AGRARIAN DEVELOPMENT HOLDINGS LTD

LAND SOUTH OF THE A5, HINCKLEY

BRIDGE LOWERING WORKS WITH FOOTWAY - STAGE 1 ROAD SAFETY AUDIT
RESPONSE REPORT

project number: ADC1839				report reference: ADC1839-RP-AB-2
version	date	author	reviewer	comments
1	22/12/2023	Phil Walker	Stuart Dunhill	first draft

Figure 2 – Problem Location Plan

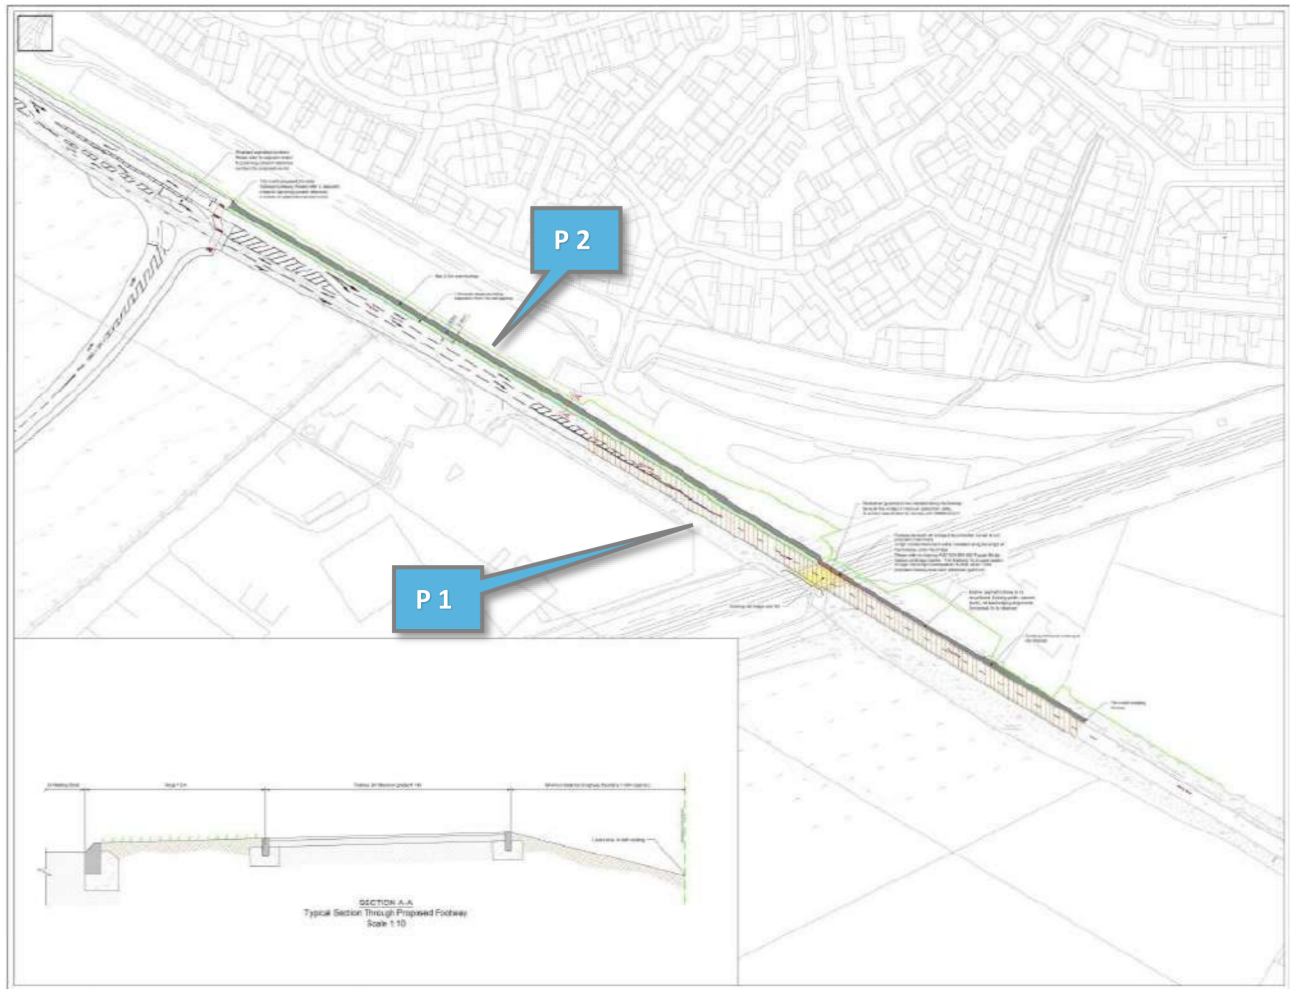
3.2. Problem 1

Location: Southwest side of Watling Street – existing retained kerb / verge.

Summary: Level differences between the carriageway and kerb / verge risk increased severity of injury in the event of a collision.

It is proposed to lower only the road channel on the southwest side of the carriageway. This will leave a 'stepped' level difference between the carriageway and kerb / verge of approximately 0.5m in places. There is a risk that this will result in an increased risk of severe injury in the event of a collision or loss of control incident.

It is recommended that the level of the southwestern kerb and verge is amended so as not to provide a severe vertical difference at the edge of the carriageway.

3.2 Dec 2023	PROBLEM 1	Agreed. The levels of the southwestern verge and kerb have been revisited and lowered to more closely match the proposed carriageway level, as indicated on revised drawing ADC1839-DR-100-P04. The level differences of this section will now be limited to a maximum kerb face height of 125mm for the main part, with a short section of 325mm high kerb face on the Trief kerb adjacent to and around the Bridge Abutment. behind the kerb line	Accepted	Scheme drawing has been amended in line with recommendation
	Location –Southwest side of Watling Street - Existing retained kerb / verge			
	Summary: Level differences between the carriageway and kerb / verge risk increased severity of injury in the event of a collision.			
	It is proposed to lower only the road channel on the southwest side of the carriageway. This will leave a 'stepped' level difference between the carriageway and kerb / verge of approximately 0.5m in places. There is a risk that this will result in an increased risk of severe injury in the event of a collision or loss of control incident

Project:	Hinckley South. A5
Title:	General Arrangement

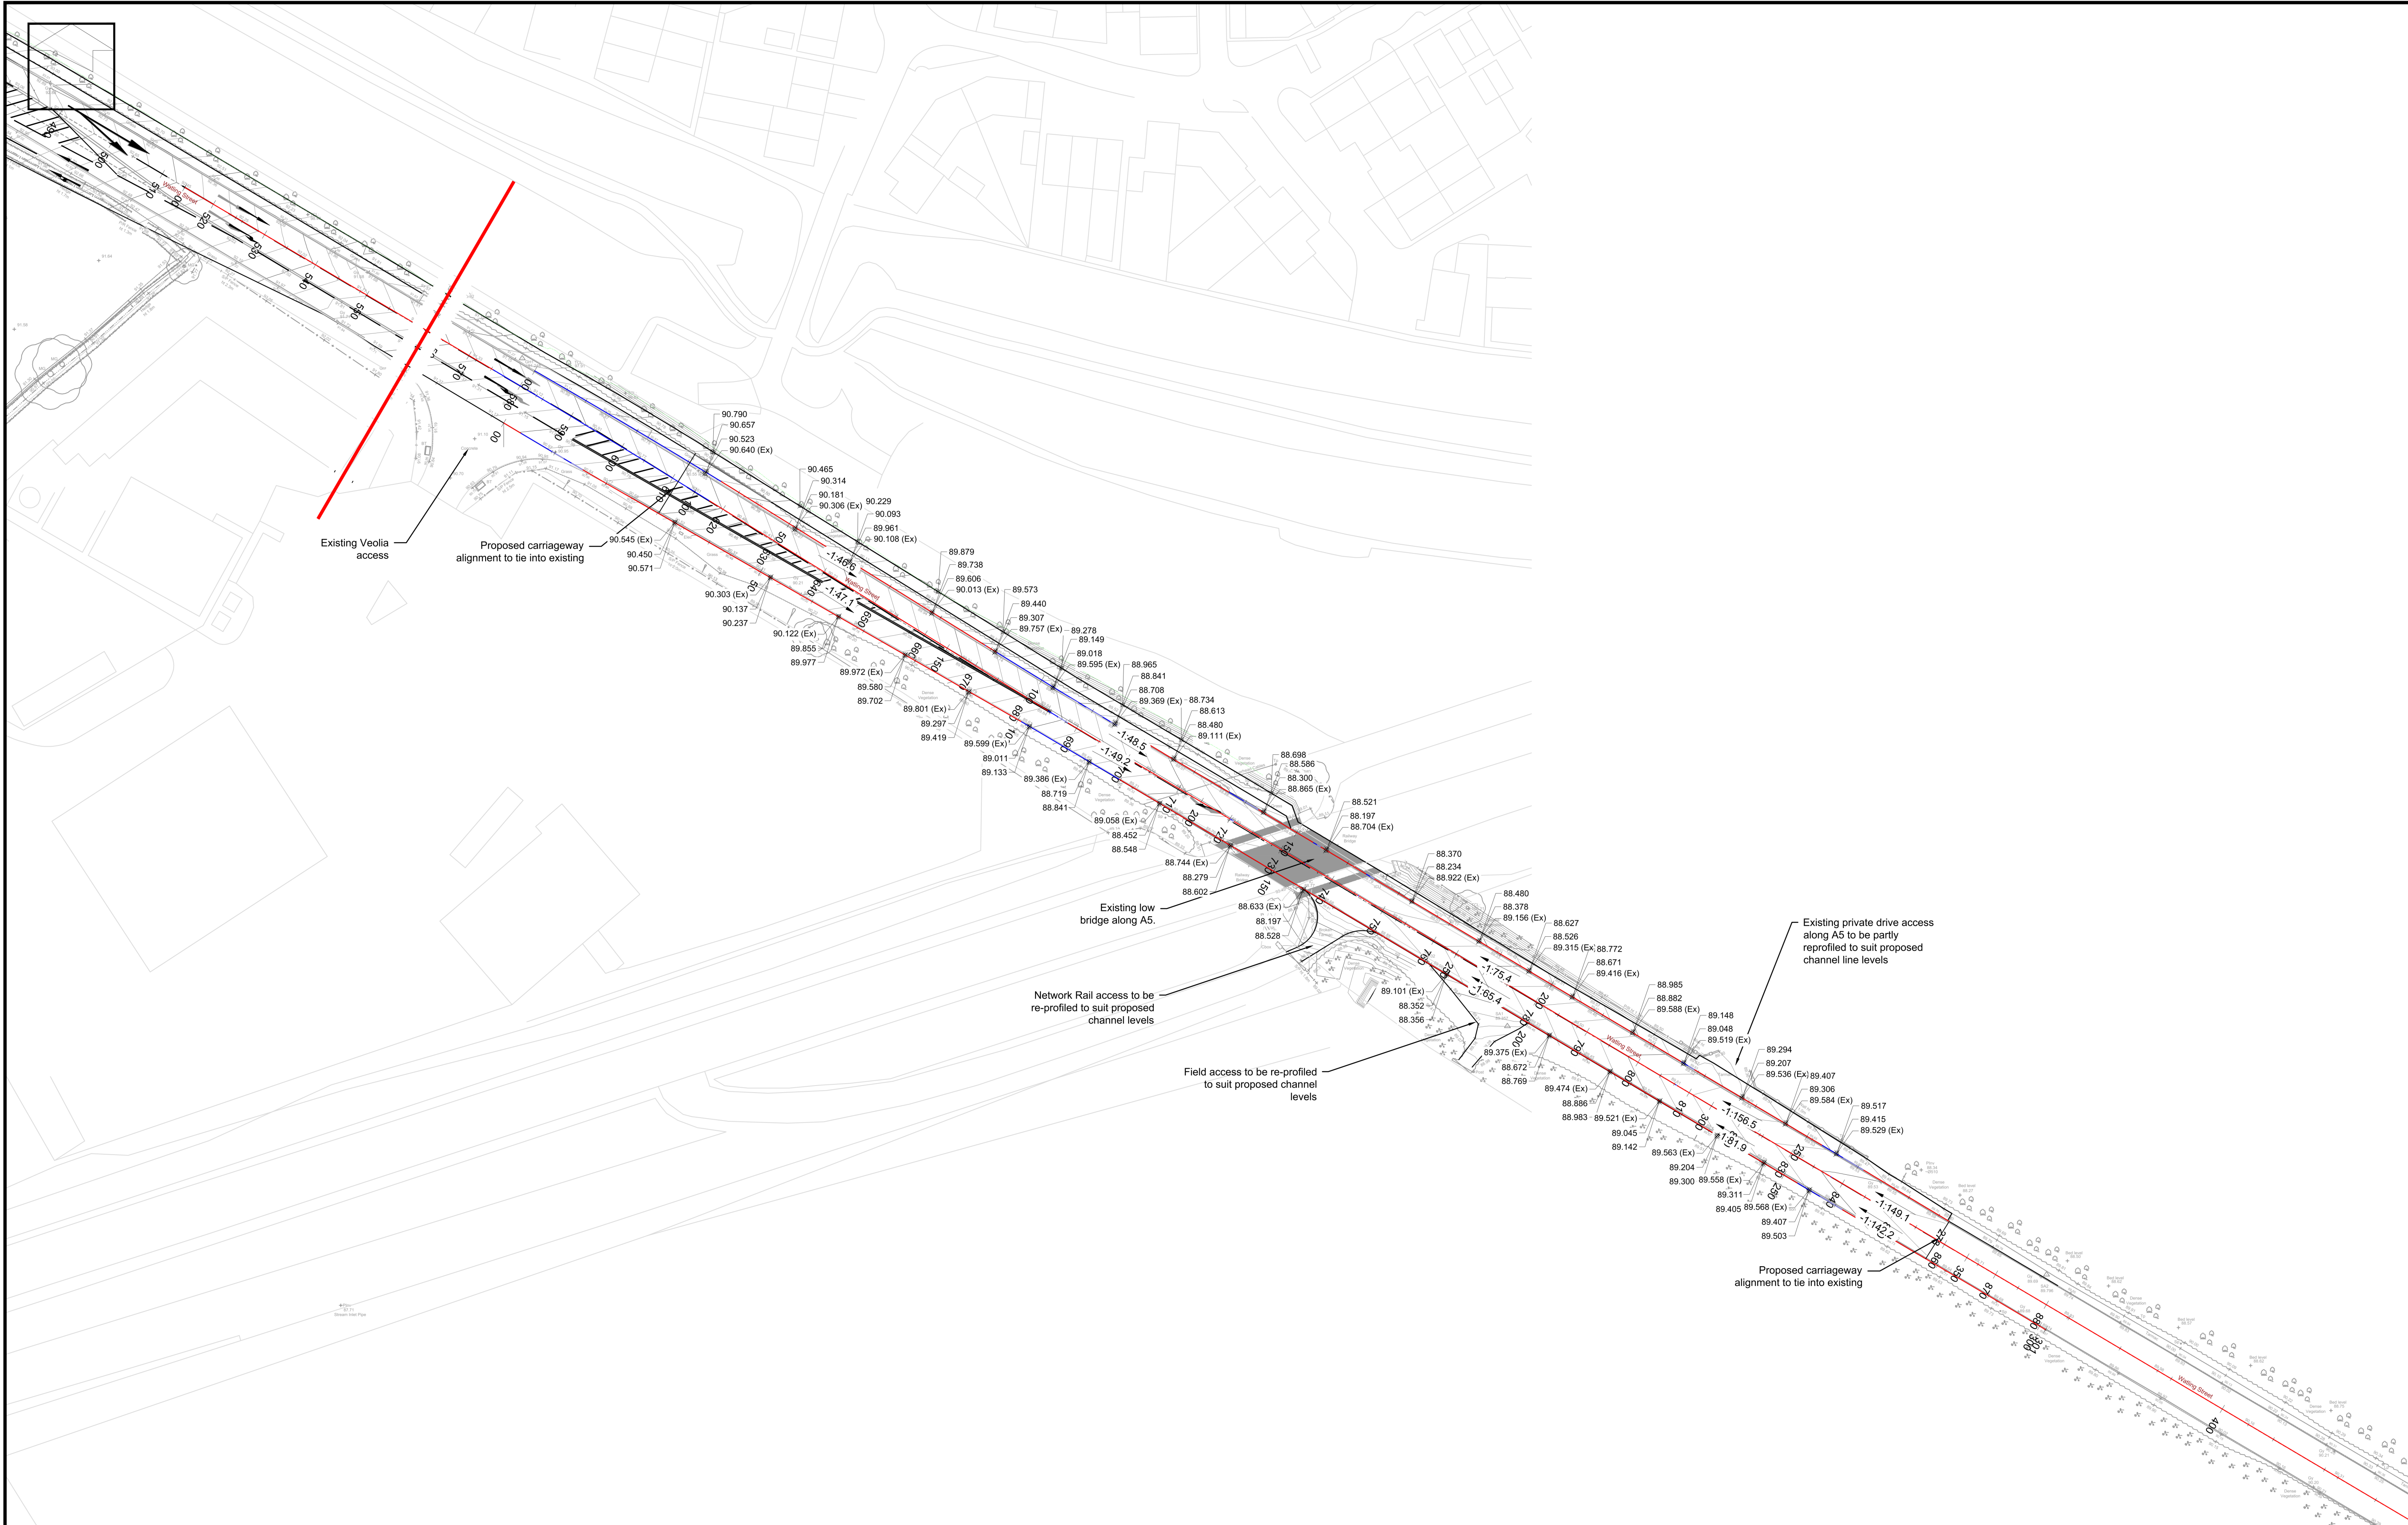
RECOMMENDATION			
	It is recommended that the level of the southwestern kerb and verge is amended so as not to provide a severe vertical difference at the edge of the carriageway

Rev	Description	Date
P04	Carriageway 3D model updated to remove large steps	22.12.23
P03	Amended to suit new footway arrangement	02.10.23
P02	Surface and Alignments amended	15.07.22

Client:				
Mountpark				
Project:				
Land at Padge Hall Farm, Hinckley				
Title:				
A5 Footway Connection Improvement Works				
Discharge of Planning Condition 11

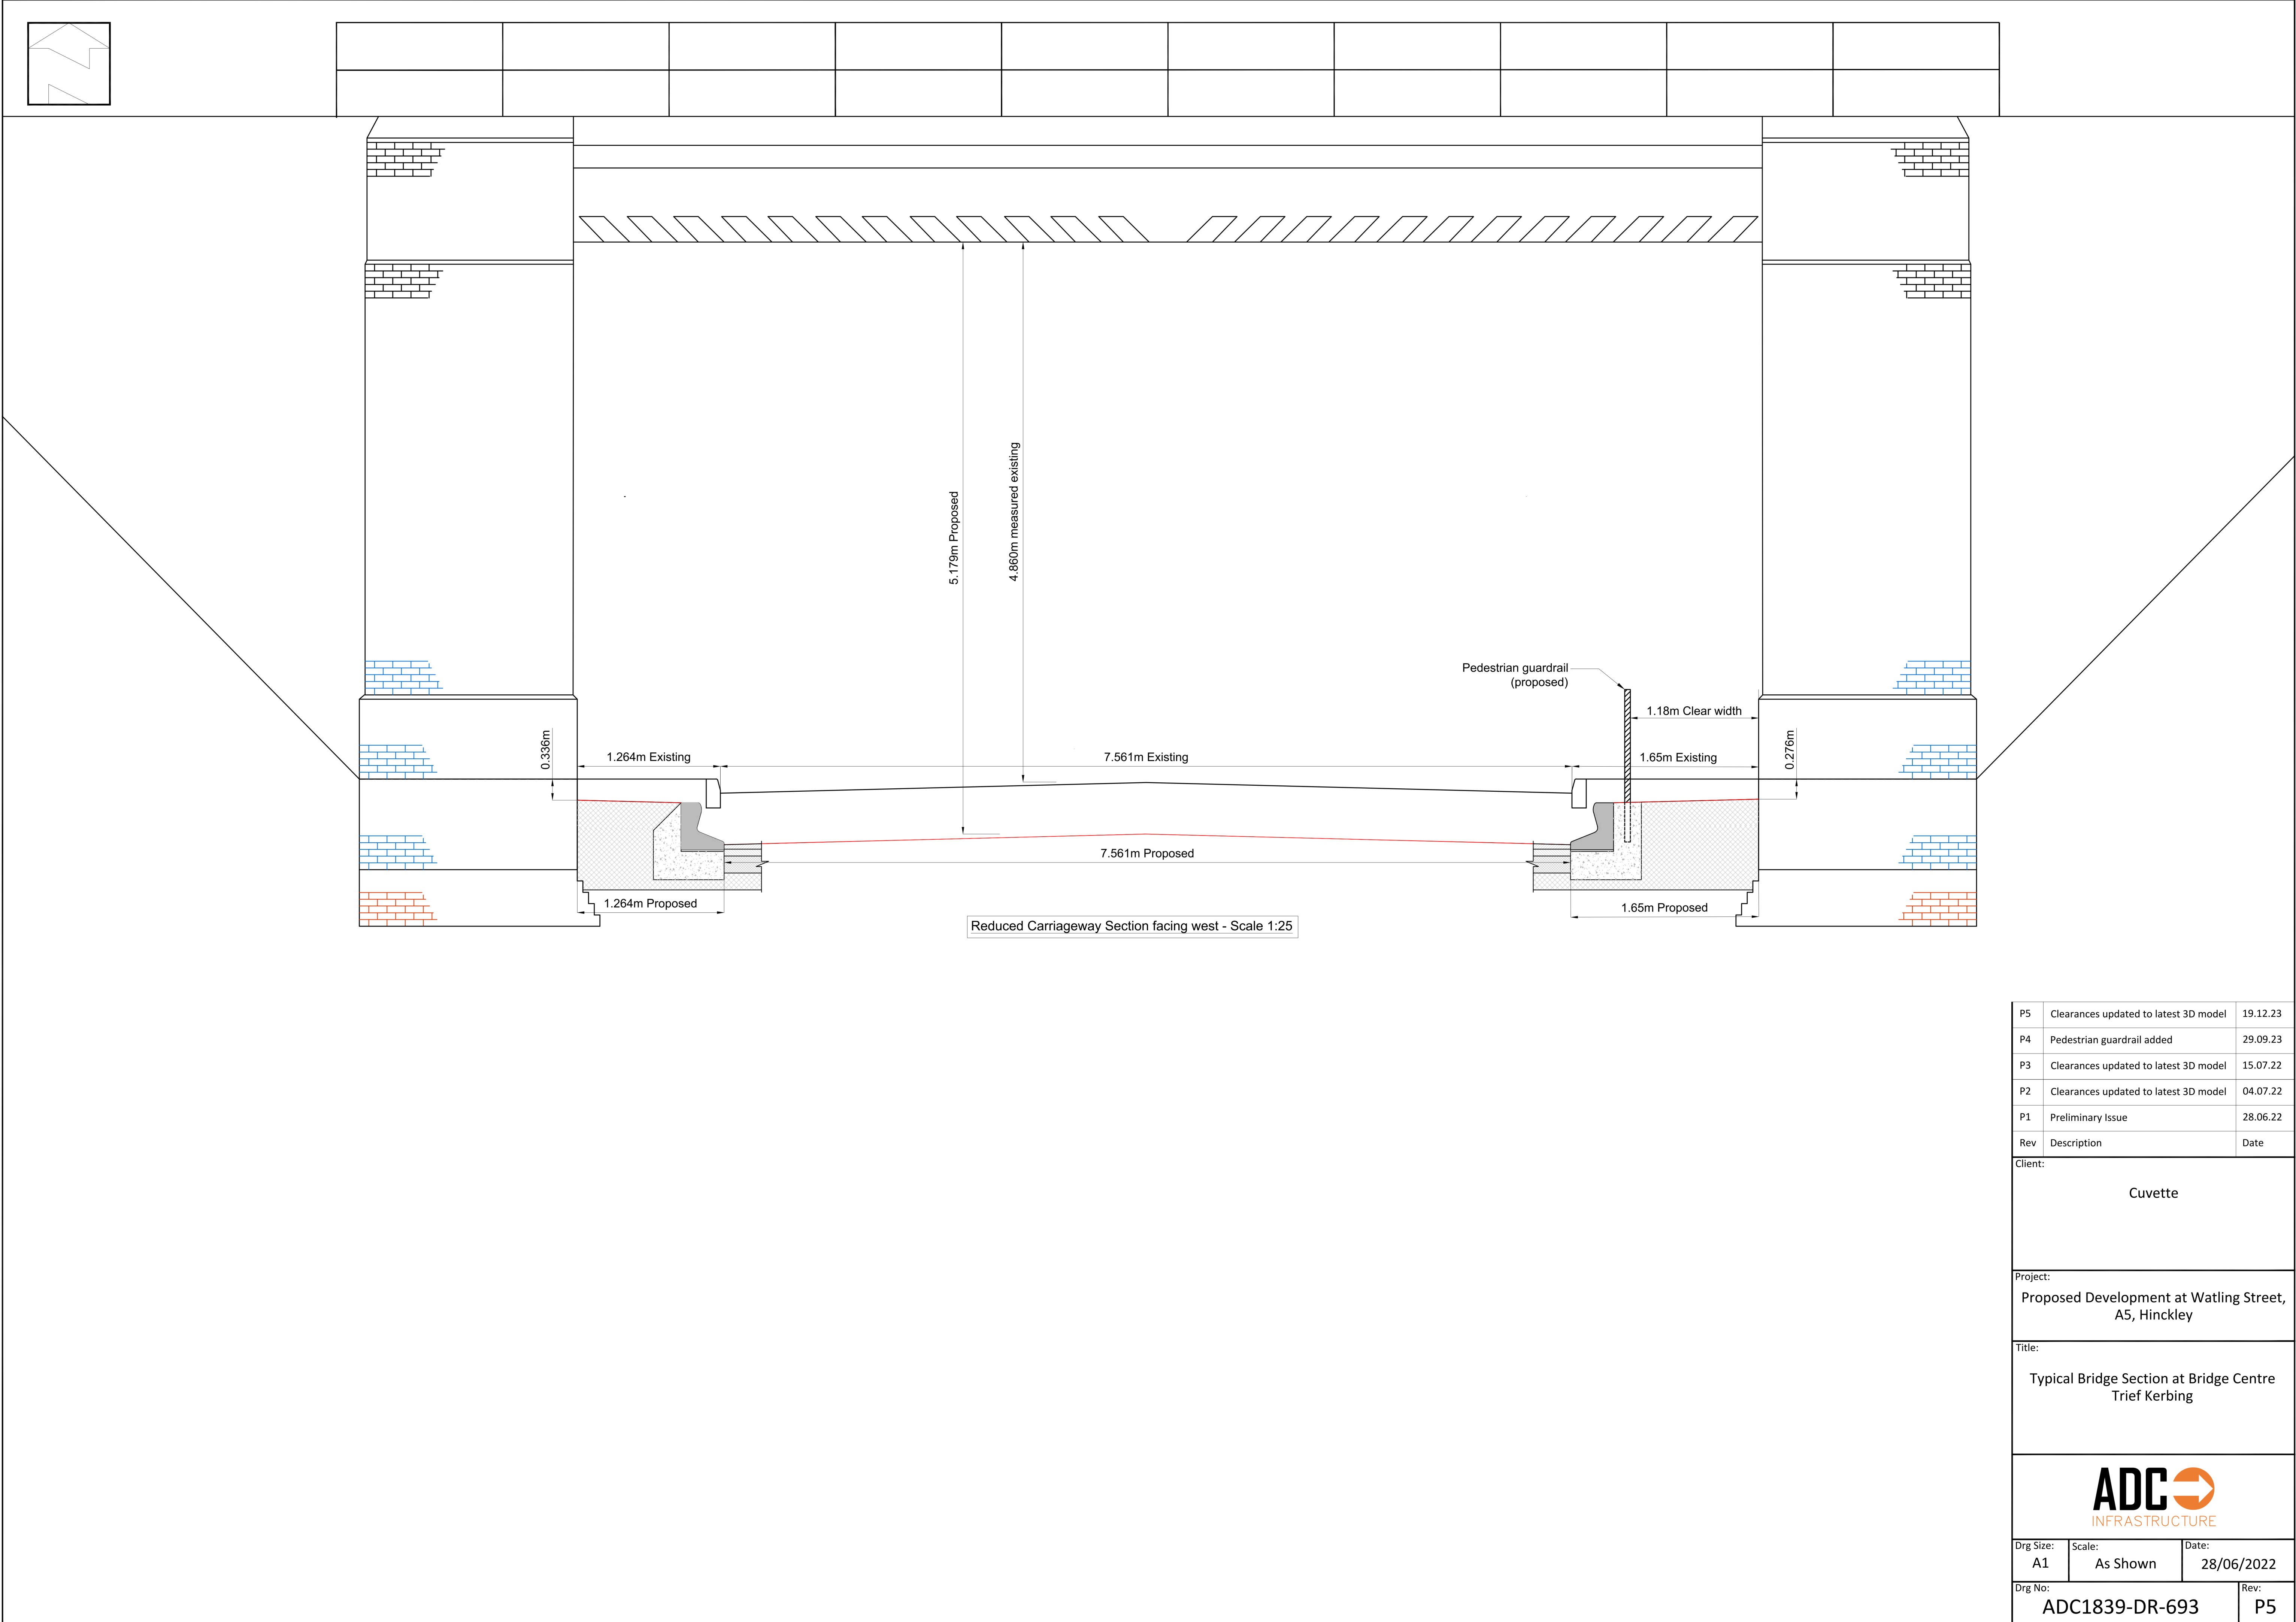
RECOMMENDATION			
	It is recommended that the levels are amended such that a steep gradient between the edge of the footway and the edge of the carriageway is not created. Should this not be practicable, it is recommended that a post and rail fence is provided where a steep gradient is created.			
Covering Letter 12/12/23	ADDITIONAL COMMENTS	Agreed. As part of the detailed design, appropriate tactile paving and signing will be provided to forewarn users that they are entering / exiting a shared footway.	Accepted	Appropriate tactile paving and signing to be agreed during detailed design
	Location –North side of A5 at proposed Site Access Junction - Footway tie-in			
	Summary: In addition to the problems raised within the report the Audit Team have observed the following point outside of the scope of the audit to bring to the attention of the designer and / or Overseeing Organisation:			
	The footway links into a proposed 3m wide shared footway / cycleway at the new site access junction. It is recommended that, as part of the detailed design, appropriate tactile paving and signing is provided to forewarn users that they are entering / exiting a shared footway

3.3 Dec 2023	PROBLEM 2	Agreed. As with the south western kerb/verge, the northern side has been amended so that a verge of maximum 2.5% (1 in 40) crossfall sits directly behind a 125mm kerb face generally, with a short section of 325mm kerb face adjacent to the bridge abutment. The pedestrian guardrail proposed for below the bridge will be extended to cover the full length of the proposed Trief kerb protecting trips/falls from the high kerb face. the revised levels are as shown on drawing ADC1839-DR-100-P04.	Accepted	Scheme drawing has been amended in line with recommendation
	Location – Northern side of Watling Street - proposed verge between the new footway and carriageway.			
	Summary: Gradient between the footway and carriageway risks vehicle to pedestrian collisions.			
	There are some sections of verge where a steep gradient (potentially up to 1:4)will be created in the verge between the edge of the footway and southeastbound carriageway. Should a pedestrian step off the footway in error there is a risk that they may fall toward the carriageway, risking being struck by a passing vehicle.

PO2	19.12.23	Details of verge updated	IA	PW
PO1	29.09.23	First Issue	LMC	PW
Rev	Date	Description	Dr	Rev
